# **BRIDLE RIDGE AT WILDHORSE RANCH**

**10501 1/2 BLUE BLUFF RD**  
**C8-2023-0259**

# VARIANCE REQUESTS

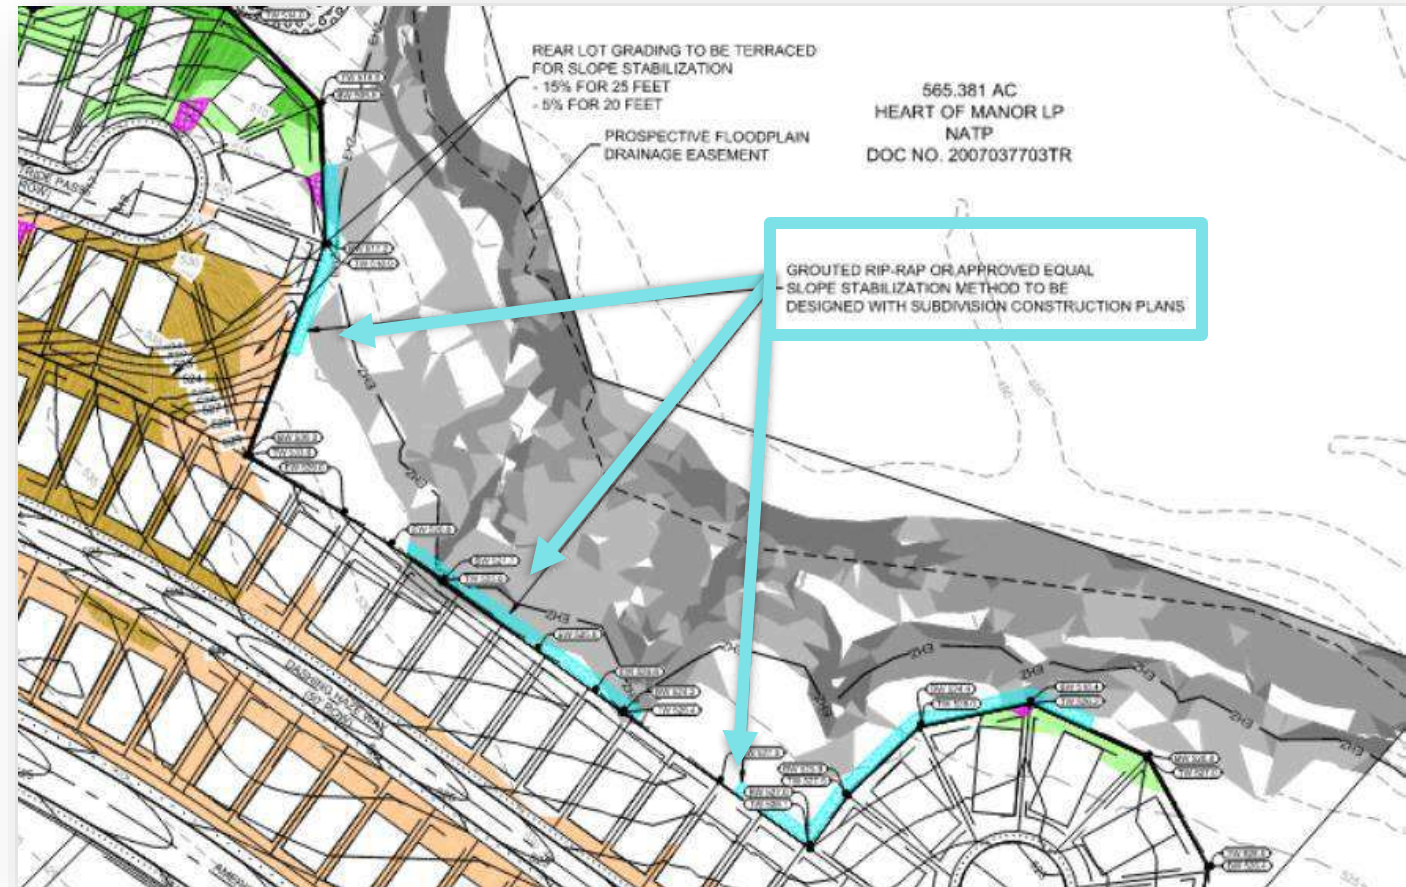
- The variance request is to allow cut over 4 feet to 15 feet.

- The variance request is to allow fill over 4 feet to 15 feet.

SLOPES EXCEEDING 15% ON CUT/FILL 4' TO 8'

3710 SQ FT / 0.09 ACRES

EXISTING SLOPES EXCEEDING 15% ON CUT/FILL OVER 8'

263 SQ FT / 0.01 ACRES
